Re: Draft Environmental Assessment for Lake Erie Energy Development Corporation's Project Icebreaker, Offshore Cleveland, OH (DOE/EA-2045)

This letter transmits the U.S. Fish and Wildlife Service's (Service) comments on the Draft EA. The Service and DOE have concluded section 7 informal consultation under the Endangered Species Act of 1973, as amended (ESA), thus this letter does not address any ESA issues.

Rain Event on S-Band Vertical Radar. Note the random directionality of most plots.
TrackPlots summarized at 15-minute intervals can easily be filtered out.

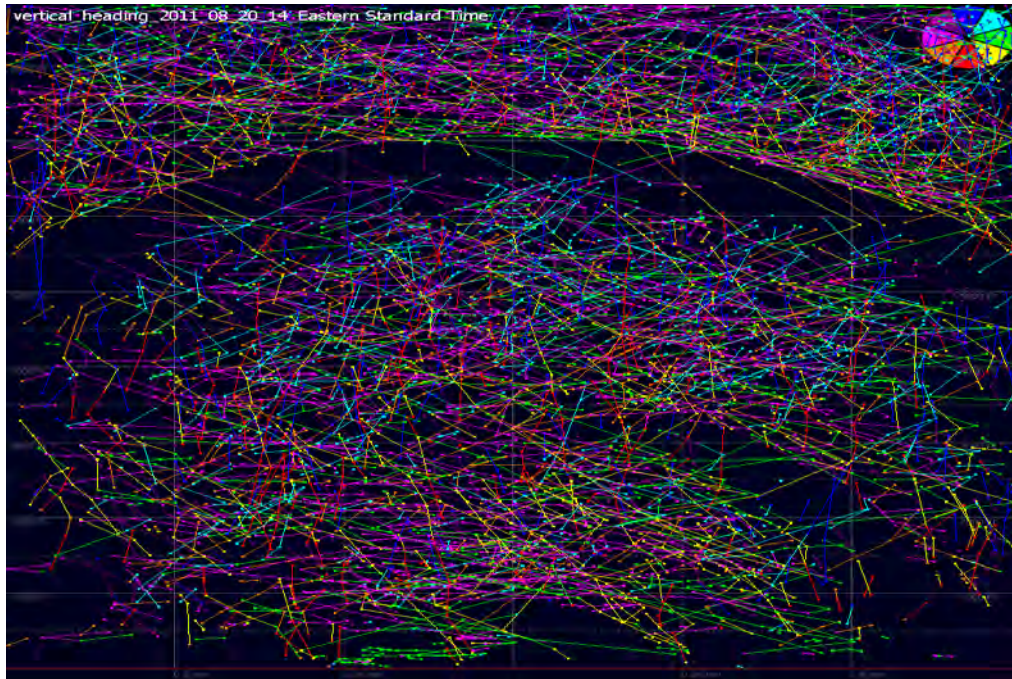
- Adequate pictorial examples of interference (waves, insects, rain) as well as high migration nights and observed phenomenon (e.g., reverse migration, directional patterns parallel to or going into shore) should be included in this report. Some examples are illustrated below:
